SR 520 - Montlake Lid & Pedestrian Land Bridge

Meeting Summary

July 18, 2019

Figure 1: 2018 WSDOT RFP proposal (top), 2018 design response to RFP (middle), and Refined plan (bottom)

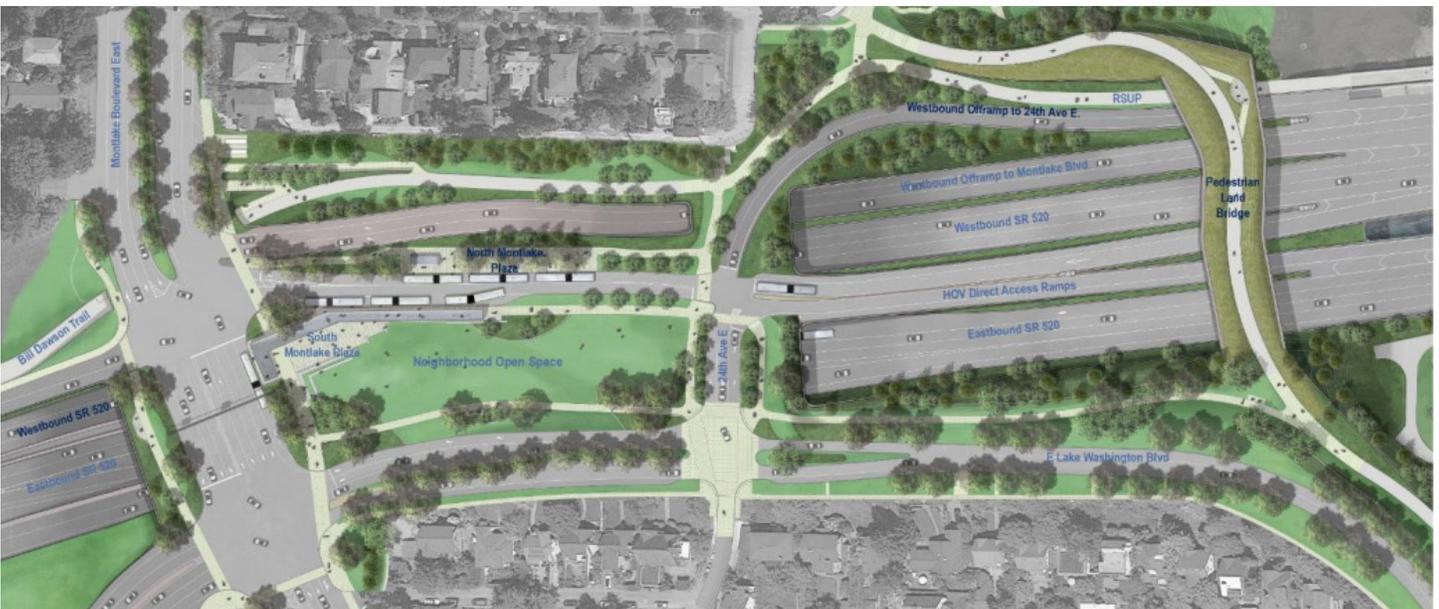
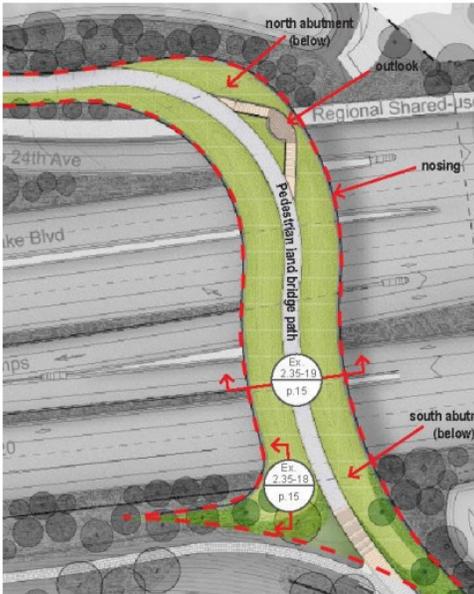
Lyle Bicknell, OPCD, complemented the project team updating the design of the pedestrian land bridge to reflect the original design intent. Lyle Bicknell also mentioned the positive improvements in how the design address the connections between the land bridge and adjacent landforms as well as the updated location of the viewpoint. Lyle Bicknell then expressed a desire for the project team to continue to include city staff, as appropriate, to review small design details that still need to be refined.

David Graves, SPR, stated that the shift in the overlook is positive move and will allow for more eyes on the adjacent park space. David Graves also mentioned that the new location shifts the view from aligning with the highway to looking out to the lake and mountains.

The SDC appreciated how the design of the pedestrian land bridge has evolved since the previous review. Commissioners then discussed the color of the girders beneath the land bridge. Several commissioners are concerned with the potential negative visual effect resulting from only painting the exterior (outside) girder. The project team then explained that painting the interior girders a dark color would cause safety and maintenance concerns. The commission then recommended the project team consider specifying a dark color for all girders located beneath the bridge. If not feasible, then carry the dark color through on the full exterior girder and the underside of all interior girders.

The SDC then encouraged the design team to have a more irregular landscape line along the outside section of the land bridge, which will be viewed from the roadway below. Commissioners agreed this would further reinforce the nature meets city concept. The commission also suggested adding up lighting in front of the vegetated area.

Commissioners agreed with the nosing of land bridge as a solution to visually break up the mass of the structure and to emphasize the elements located on top of the land bridge. Commissioners also agreed with the different sections of the land bridge aligning with the roadway below.

The SDC commended the project team for positive improvements made to the updated design of the outlook, but reminded the project team of the original design proposal which included a vegetated zone between the overlook and bridge edge, creating a layer between the pedestrian and roadway below. The commission then expressed their concern with the proposed lean rails. Commissioners thought it was odd to provide two separate lean rails and encouraged the project team to continue to explore more resolute and intentional design solutions for the railing, possibly through the addition of interpretive elements. The Commission then recommended providing a step on the pedestrian bridge view point to provide view over railing.

The SDC recognized the challenges with grading/elevation differences, but encouraged the project team to better understand the appropriate location for the gathering area/ mixing zone north of the pedestrian land bridge adjacent to Hamlin St. Commissioners recommended the area be located further east to provide a buffer between the gathering space and neighborhood.

1. Return for a subcommittee meeting to review detailed refinements to the bridge including the landscape line, how column meets, batter joints, etc.
2. Return for a subcommittee meeting to discuss the approach to sustainability and opportunity to incorporate sustainable measures.
3. Consider specifying a dark color for all beams located beneath the bridge. If not feasible, then carry the dark color through on the full front beam and the underside of all interior beams.
4. Consider the integration of interpretative elements within the design of the pedestrian land bridge overlook
5. Refine the location of the gathering area/mixing zone with the adjacent neighborhood north of the pedestrian land bridge
6. Consider providing a step on the pedestrian bridge view point to provide view over railing

Figure 2 (top): Evolution of Pedestrian Land Bridge: 2018 WSDOT RFP proposal (left), 2018 design response to RFP (middle), and Refined plan (right)

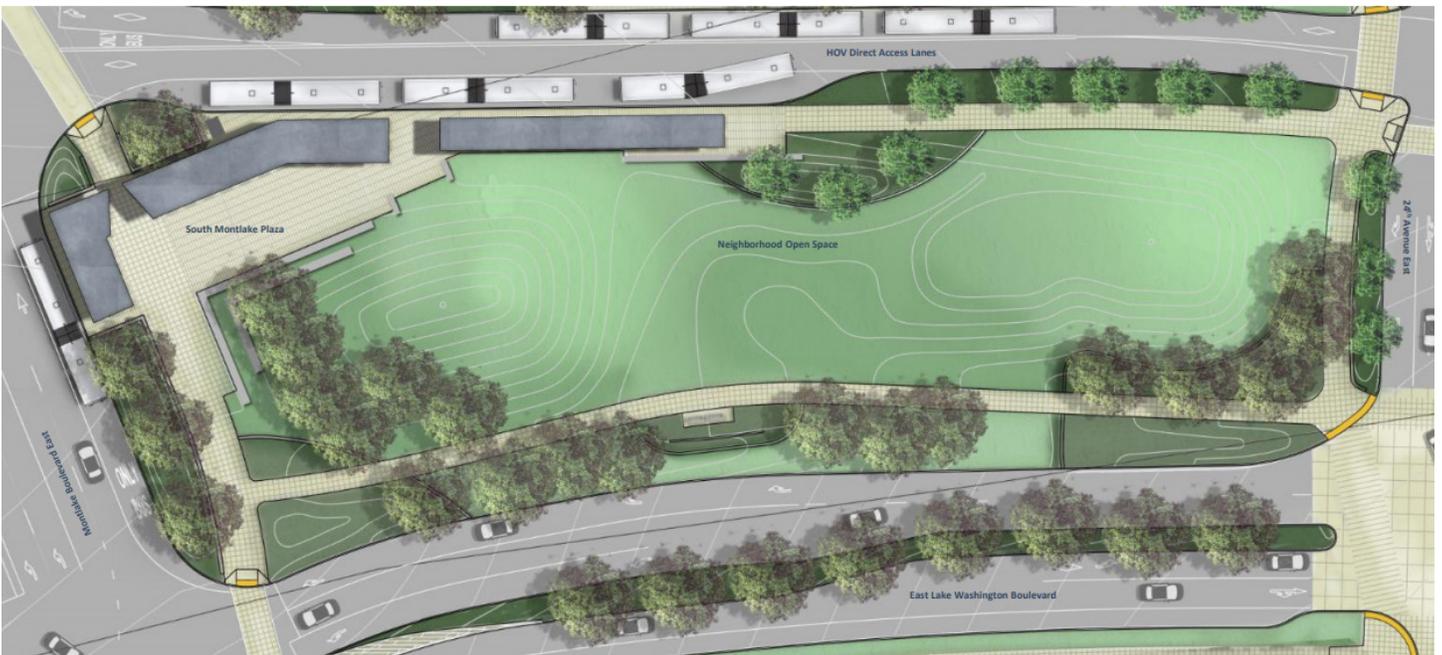
The SDC encouraged the project team to provide more seating opportunities in and/or oriented towards the open space area instead of facing the plaza. Commissioners also encouraged the project team to consider seating along pathways surrounding the Montlake Lid. Although the Commission then mentioned that the proposed art patterns for the seating elements could be used at different scales, depending on the size of the surface, several commissioners encouraged the project team to use patterns that are pedestrian scaled.

The SDC is concerned with the current design proposal for the bus shelter at the northwest edge of the Montlake Lid. Commissioners commented that the original proposal included one continuous shelter that expressed a transit center design vernacular but that the updated design included a series of stand along shelters, which resulted in the shelters appearing to be unaligned and cluttered. The SDC strongly recommended the project team consider reintroducing the original design intent by including one continuous bus shelter. Commissioners then commented that the proposed plaza and adjacent shelters will serve transit users and are not likely to serve as a community gathering space.

The SDC also encouraged the project team to use pavement treatments that will correspond with different modes of transportation and will serve to slow users as they approach mixing zones. The Commission then cautioned the project team against having wide pathways near the plaza, which will facilitate quick movement. The SDC also recommended the project team tighten the radius of the multi-use pathway connecting the North Montlake Plaza to the Bill Dawson Trail to reduce cyclist speed.

The SDC also strongly encouraged the project team to further evaluate the proposed design of the 24th Ave E and E Lake Washington Blvd. intersection. Specifically, commissioners requested more information addressing types of movements based on transportation mode (vehicular, bicycle, pedestrian, etc) as well as more information as to how movement is influenced by pavement and signage.

The SDC had an issue with the size of the gantry holding directional signage above Montlake Blvd. The Commission recommended the project team reduce the sign gantry to match the scale of the street. Commissioners then expressed their concern with the elimination of the landscape median along Montlake Blvd.

The SDC recognized that the proposed Portage Bay Overlook will provide a unique view of the new bridge and water but recommended the project team consider reducing the size. Commissioners then recommended the project team use the additional area gained from reducing the size of the overlook to incorporate other elements, such as the median along Montlake Blvd.

1. Return for a subcommittee meeting to discuss the canal reserve addition buffer design
2. Consider reintroducing the original design intent by including one continuous bus shelter. If this is not pursued, reexamine the slope directions and shape of the ends
3. Consider tightening the radius of the multi-use pathway connecting the North Montlake Plaza to the Bill Dawson Trail to reduce cyclist speed
4. Reduce the sign gantry on Montlake Blvd. to match the scale to street
5. Consider reducing the size of the Portage Bay Overlook
6. Consider reincorporating the median on Montlake Blvd.
7. Consider adding seating throughout the Montlake Lid
